COVER SHEET CIVIL PLANS FORTRESS - PUYALLUP

Job Number 22085 Sheet C1 of 34

No.	Date	By	Chd.	Appr.	Revision
2	03/05/24	DL	DL	JSG	RESPONSE TO CITY COMMENTS, DATED FEBRUARY 06, 2024
	02/27/24	DL	DL	JSG	BID SET
1	12/06/23	DL	DL	JSG	RESPONSE TO CITY COMMENTS, DATED 10-06-2023

**GRADING DETAIL 5**  
1"=10'

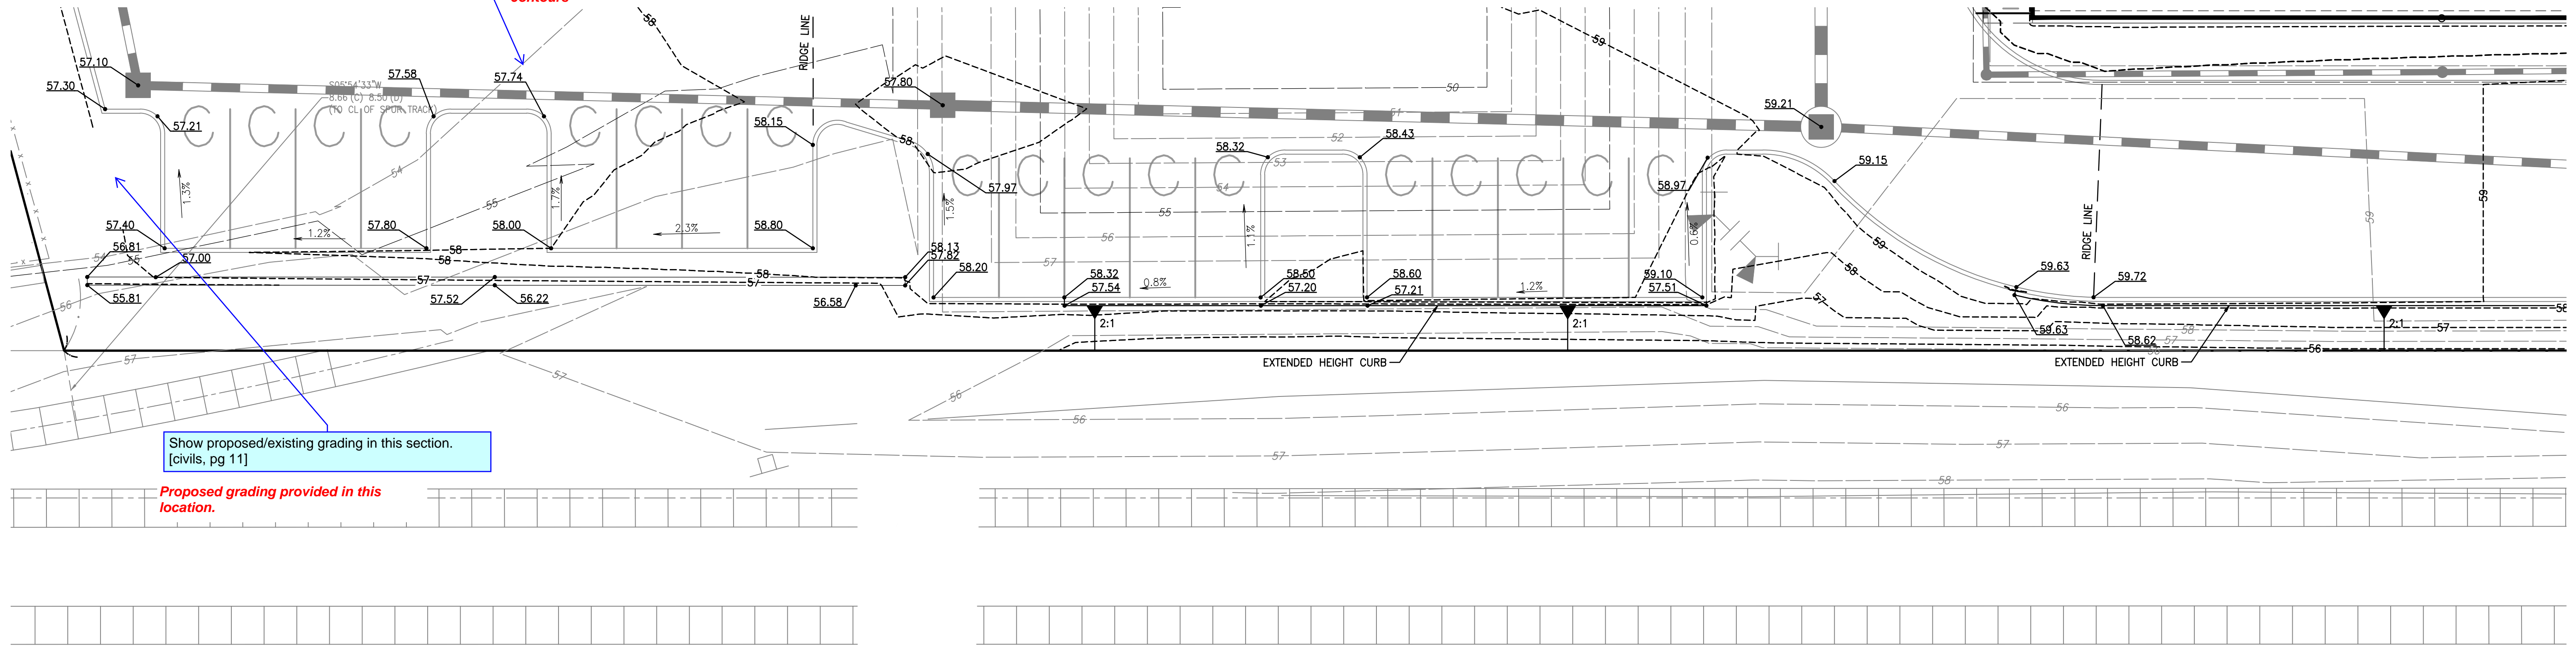
Show proposed/existing grading in this section.  
[civils, pg 11]

Proposed grading provided in this  
location.

PORTION OF SE QUARTER OF SEC 27, TWN 20 N, RGE. 4 E, W.M.  
CITY OF PUYALLUP, PIERCE COUNTY, WASHINGTON  
**FRONTAGE IMPROVEMENT PLAN**

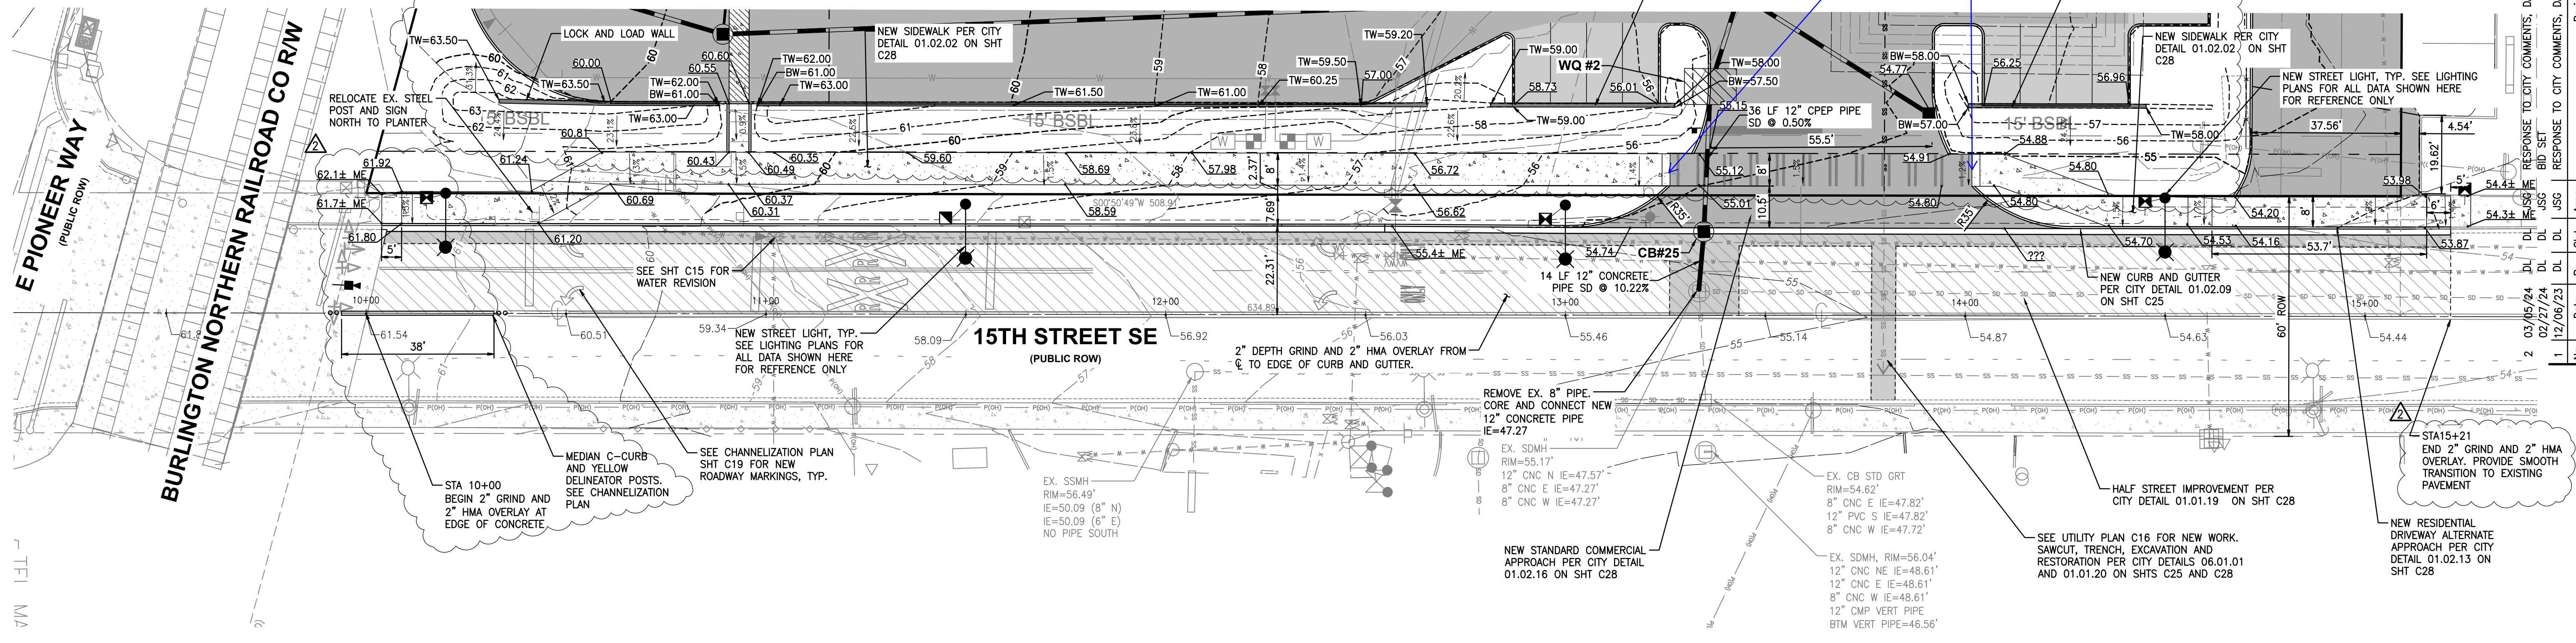
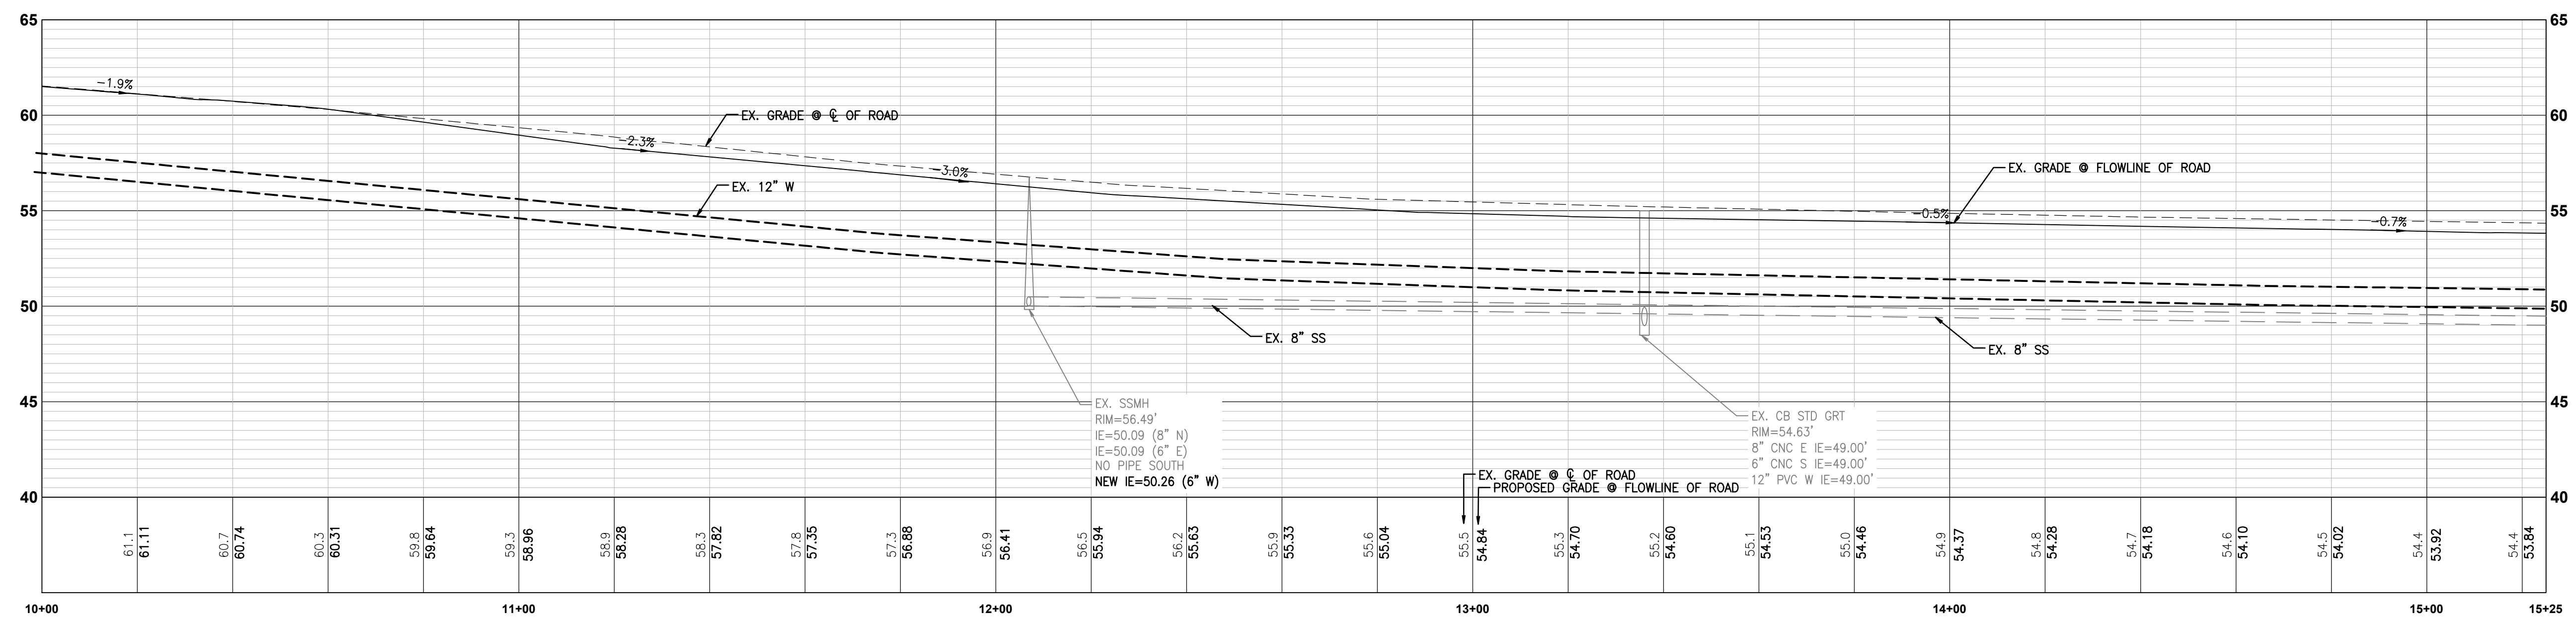
Detectable warnings added at both drive approaches  
Provide detectable warning surfaces if this approach will be stop controlled leaving the site. [civils, sheet C18]

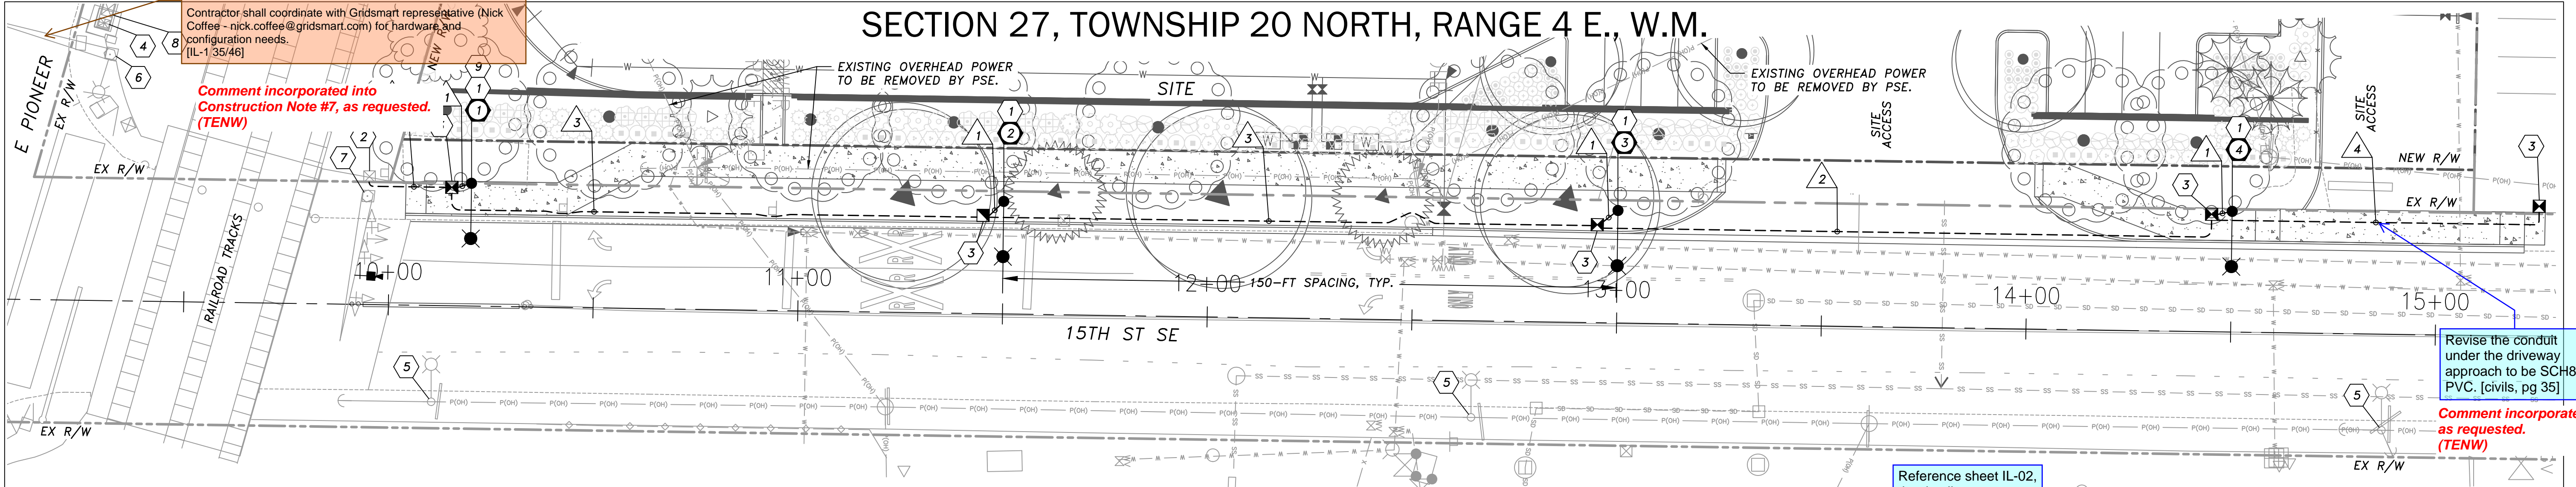
Revise the conduit under the driveway approach to be SCH80 PVC. [civils, pg 35]

Reference sheet IL-02, the details are not shown on this sheet. [civils, pg 35]

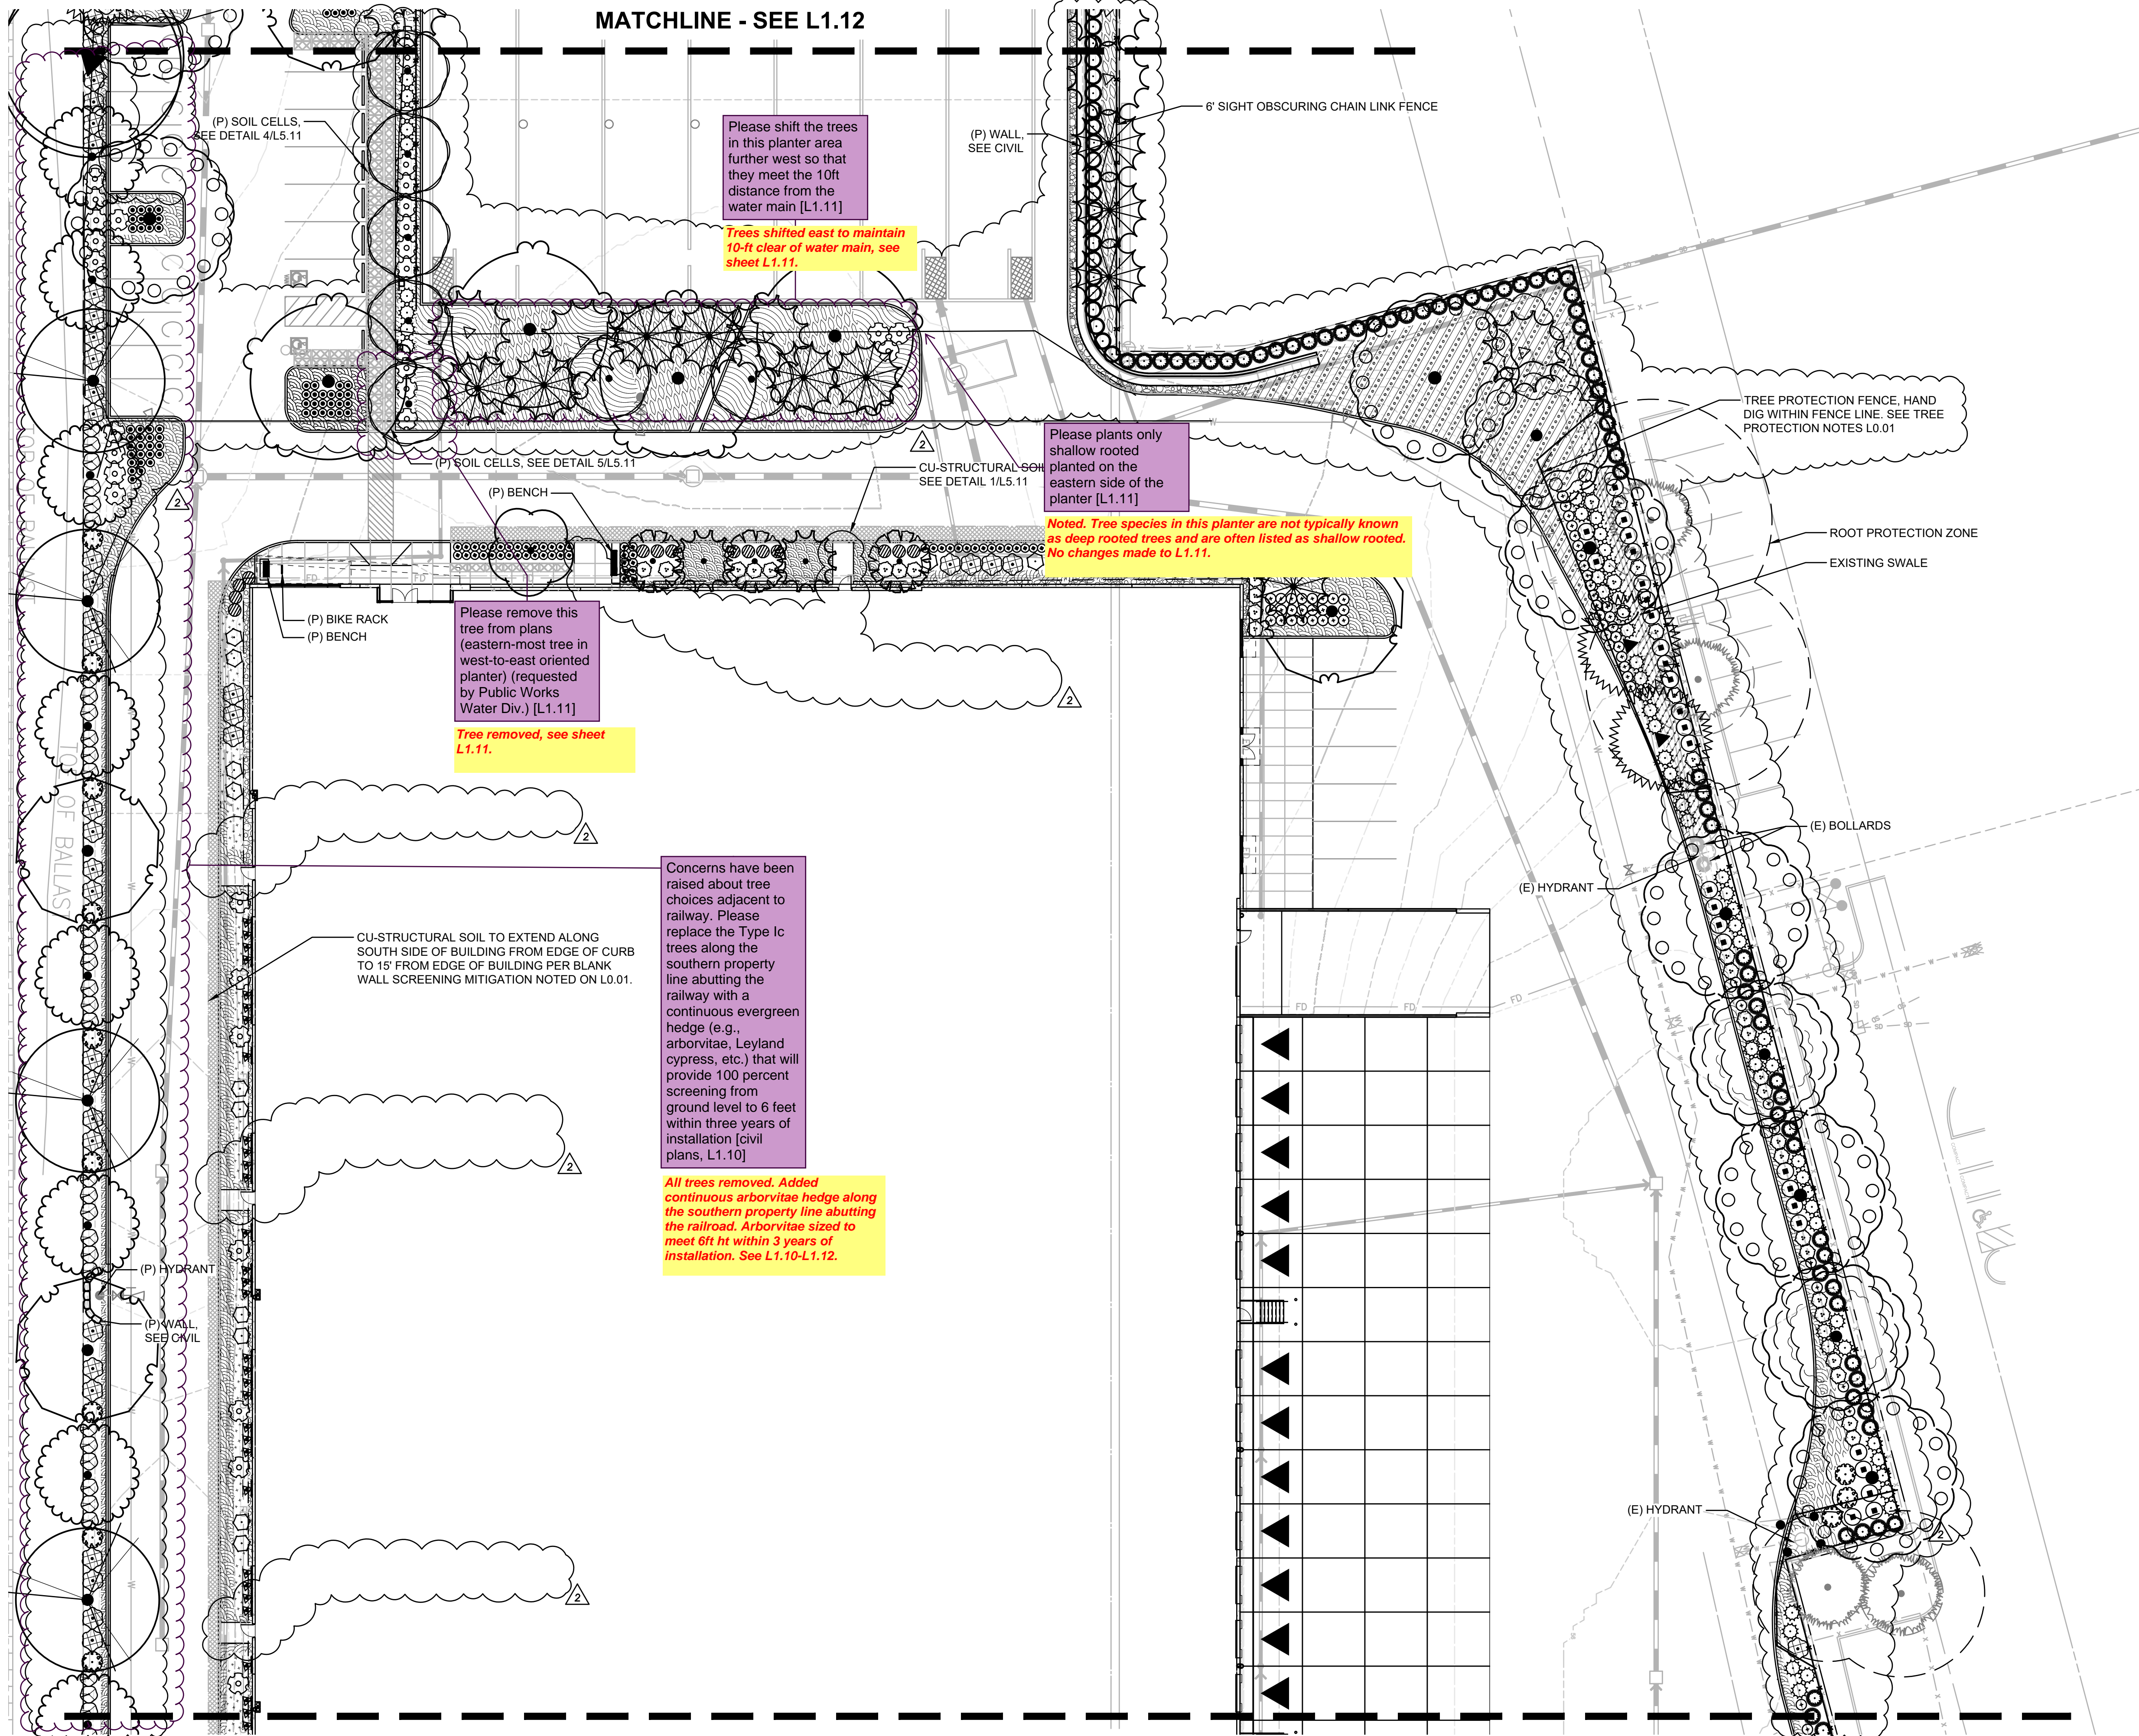
Please shift the trees in this planter area further west so that they meet the 10ft distance from the water main [L1.11]

Please plants only shallow rooted planted on the eastern side of the planter [L1.11]

Please remove this tree from plans (eastern-most tree in west-to-east oriented planter) (requested by Public Works Water Div.) [L1.11]

Concerns have been raised about tree choices adjacent to railway. Please replace the Type Ic trees along the southern property line abutting the railway with a continuous evergreen hedge (e.g., arborvitae, Leyland cypress, etc.) that will provide 100 percent screening from ground level to 6 feet within three years of installation [civil plans, L1.10]

Trees shifted east to maintain 10-ft clear of water main, see sheet L1.11.

Noted. Tree species in this planter are not typically known as deep rooted trees and are often listed as shallow rooted. No changes made to L1.11.

Tree removed, see sheet L1.11.

All trees removed. Added continuous arborvitae hedge along the southern property line abutting the railroad. Arborvitae sized to meet 6ft ht within 3 years of installation. See L1.10-L1.12.
